Access Compliance Report

Public Rights-of-Way

(Curb Ramps)

Intersection ID: 42722	Main Street: WAKEROBIN_LN	Cross Street: BACK_CREEK_CHURCH_RD	Location: E
ADA ID: 06D32DE7722F	Ramp Type: Perp	Initial Pass/Fail: Fail	Overall Compliance: No
Severity Score: 10			
Codes/Mitigation Info/Possible Solution		Field Measurements/Component Compliance

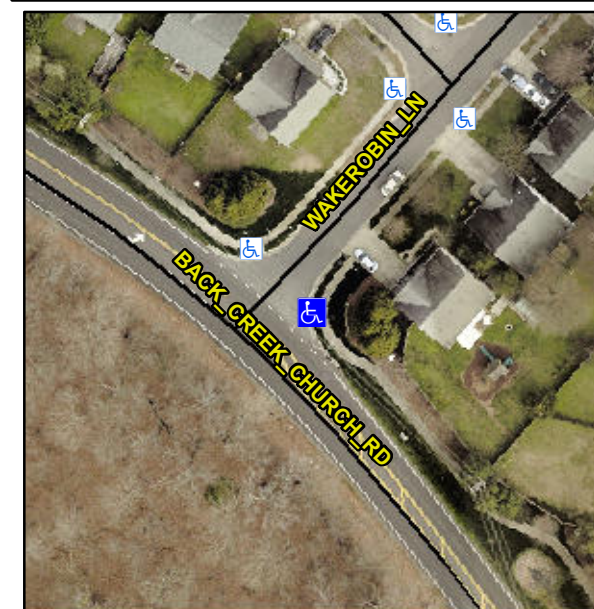
Not Found, R304.5.1, R304.5.3

Compliance	Description	Data	Compliance	Description	Data
N/A	Ramp Length (in)	49.0	Yes	Ramp Slope (%)	5.1
No	Ramp Width (in)	39.0	No	Ramp XSlope (%)	3.1
N/A	Flare Type LT	N/A	N/A	Flare Type RT	N/A
N/A	Flare Slope LT (%)	N/A	N/A	Flare Slope RT (%)	N/A
N/A	Flare Traversable LT?	N/A	N/A	Flare Traversable RT?	N/A
N/A	Landing Length (in)	N/A	N/A	DWS Provided?	N/A
N/A	Landing Width (in)	N/A	N/A	DWS Contrast?	N/A
N/A	Landing Slope (%)	N/A	N/A	DWS Length (in)	N/A
N/A	Landing X Slope (%)	N/A	N/A	DWS Full Width?	N/A
N/A	Landing Curb? (Y/N)	N/A	N/A	DWS Offset (in)	N/A
N/A	Shared Landing?	N/A			
N/A	Gutter Ponding?	N/A	N/A	Gutter Slope (%)	N/A
N/A	Gutter Lip Ht (in)	N/A	N/A	Gutter X Slope (%)	N/A
N/A	Painted X Walk1?	No	N/A	Painted X Walk2?	N/A
	X Walk 1 Direction	To NW		X Walk 2 Direction	N/A
N/A	X Walk 1 Width (in)	N/A	N/A	X Walk 2 Width (in)	N/A
	X Walk 1 Slope (%)	0.6		X Walk 2 Slope (%)	N/A
	X Walk 1 X Slope (%)	2.0		X Walk 2 X Slope (%)	N/A

Remove & Replace Entire Ramp.
